Section 4.55(2) Modification Application

North Sydney Public School Upgrade
182 Pacific Highway, North Sydney

Submitted to Department of Planning and Environment
on behalf of School Infrastructure NSW

Figure 4: Extract of approved site entry plan on drawing SD-1109 (Source: Fulton Trotter)

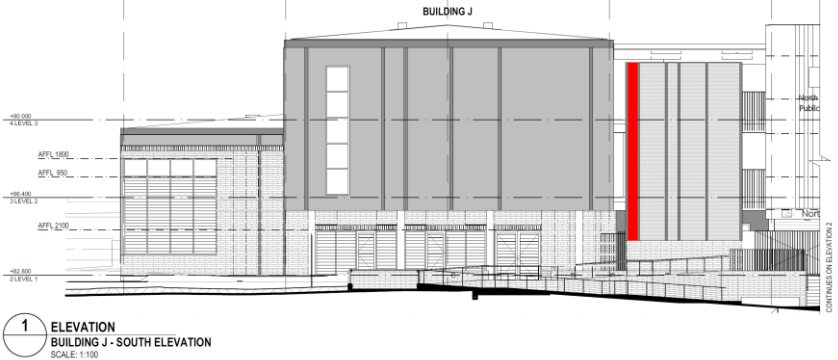
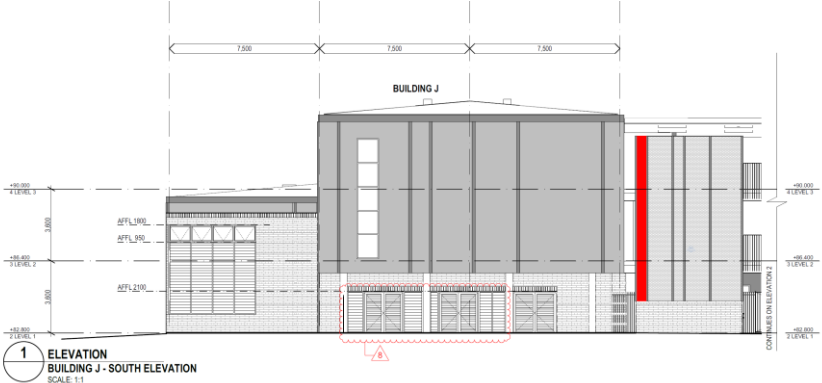
- Reconfigure the approved Bay Road entry ramp;
- Partial demolition and subsequent later reinstatement of the heritage-listed fence on Bay Road and corresponding stone gutter to facilitate construction access to the site;
- Provision of an additional cleaner's cupboard on level 2 of approved Building I;
- Minor relocation of the approved library entry doors as a consequence of providing the cleaner's cupboard;

Figure 16: Proposed vehicle entry and exit from the site (Source: Taylor)

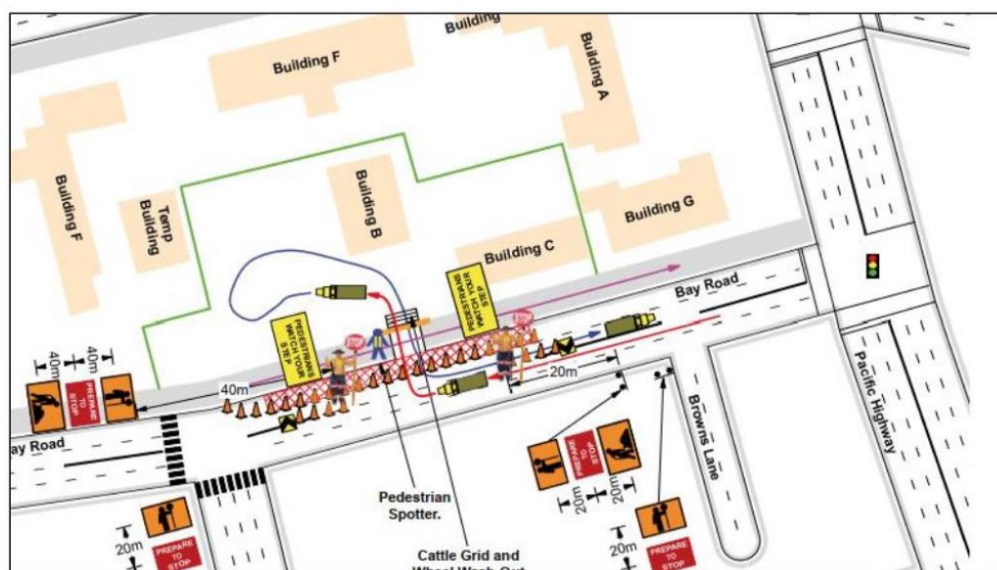
There will be a short term visual impact associated with the proposed construction vehicle access as viewed from Bay Road with the temporary removal of part of the heritage listed fence. This minor impact is considered to be acceptable from a visual impact perspective given its short term/temporary nature and subsequent reinstatement (following completion of construction), noting the approved 3.5 metre opening for the pedestrian entry will be retained.

The proposed amendment to the heritage fence results in a positive construction management outcome for the development, thereby enabling the construction works to be completed on time and to schedule. The Site Management Plan prepared by Taylor (Appendix 7) discusses the updated construction traffic management process for the works. As seen in the below figure extracted from Appendix 7, vehicles for construction will enter through the proposed vehicular entry off Bay Road. A turning circle will be provided on-site to allow all vehicles to enter and exit the site in the forward direction. Two traffic controllers, equipped with the required equipment will be stationed on both sides of Bay Road to halt traffic and pedestrian both entering and exiting the site. In accordance with condition B15 of the SSD, a Construction Traffic and Pedestrian Management Sub-Plan will be prepared prior to the commencement of works
